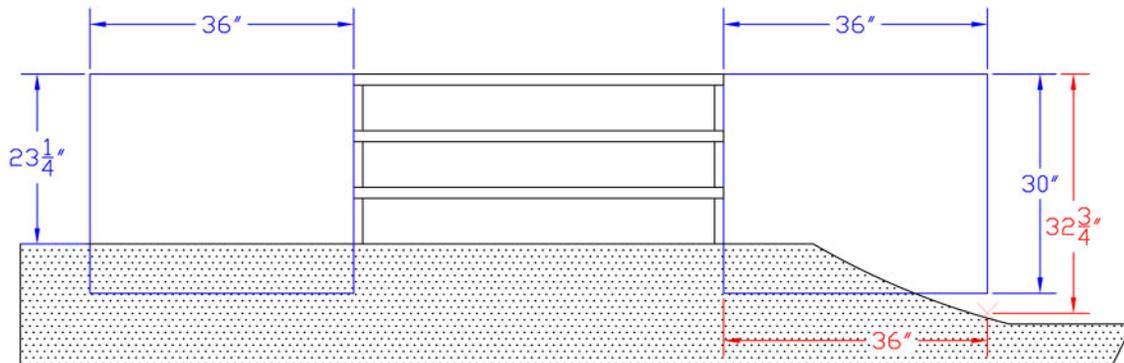
The key part of this change to IBC 1013.1 is submitted in order to clarify how the height measurement which triggers the guard requirement is made relative to proximity to the adjacent fall-off. This is illustrated in the following figure:

The view is taken from the landing of a 3 riser stair, looking towards the face of the risers.

IBC 1013.2: The technical portions of this change are the changes that stipulates that the provisions are applicable to only required guards and that a fixed seat becomes a potential walking surface to a child and thus warrants the guard height to be measured from that point. The remainder does not change the intent but rather provides standardized text dealing with stair treads and the determination of how to measure guard height. This public comment revises the term to "fixed seating" so as to clarify the measurement, using common terminology. Fixed seating represents a walking surface that is sure to be utilized by children. As such, the measurement of the guard must be taken from this location to address the hazard of a child falling over the guard. It is impossible for the code to regulate ornamentals such as planters, furniture and the like and this proposal does not intend to regulate them.

1013.2 (IFC [B] 1013.2) (Supp) Height. Required guards shall ~~form a protective barrier~~ be not less than 42 inches (1067 mm) high, measured vertically above the adjacent walking surfaces, adjacent fixed seating or the line connecting the leading edge edges of the tread treads , adjacent walking surface or adjacent seatboard.

Requirements with Code Change

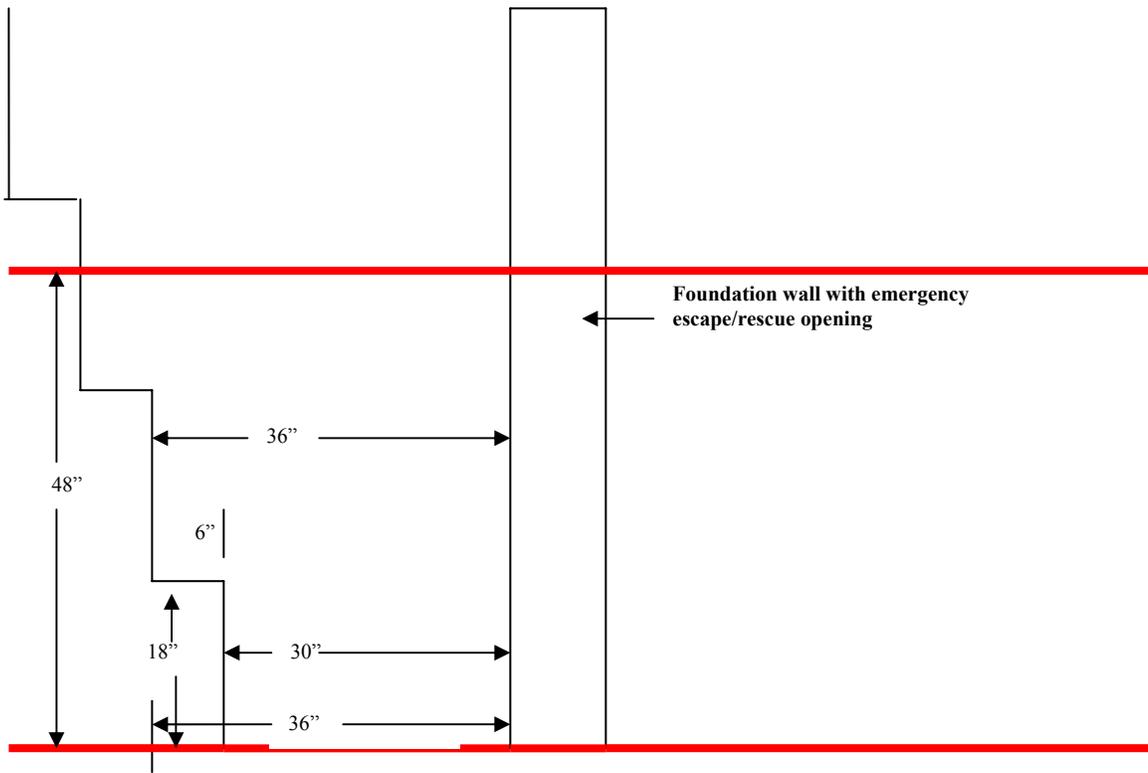
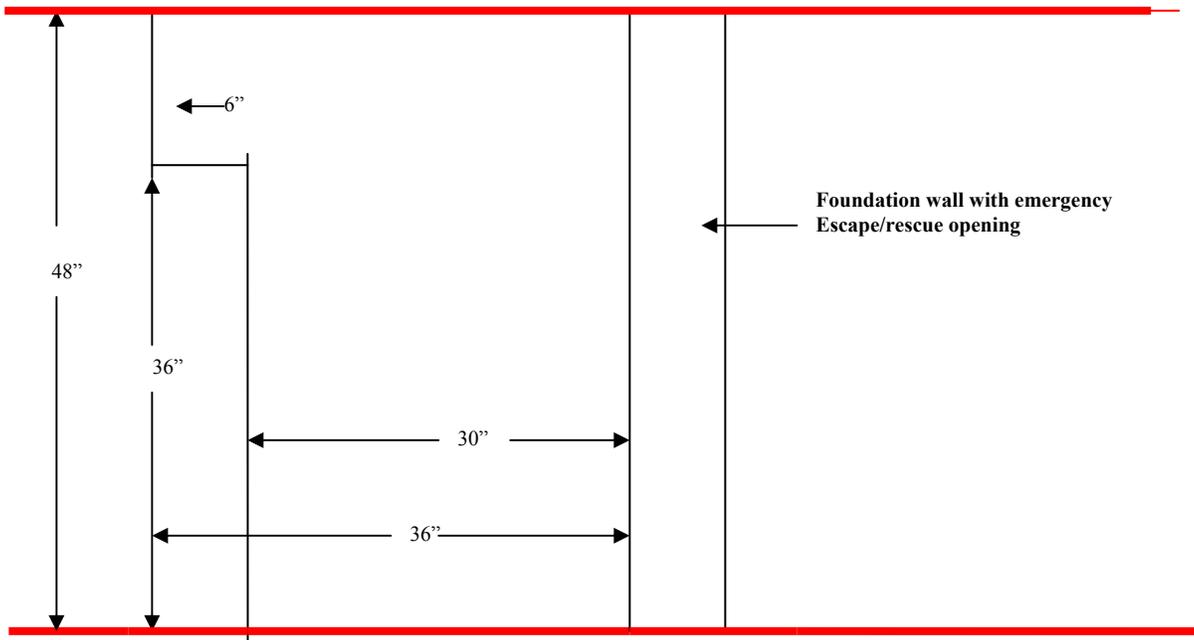
Having this required space encroached upon in excess than 18 inches (40.5 cm) measured from the bottom of the window well would inhibit the movement of emergency service personal during a rescue.

Having the first step higher than 18 inches (40.5 cm) above the bottom of the window well could create a situation where escaping the window safely may be hindered.

It is the intent of this code change to provide enough area as to not hinder the rescue of persons or the escape of persons from a below grade area during life threatening conditions, and to provide some parameters for window well steps.
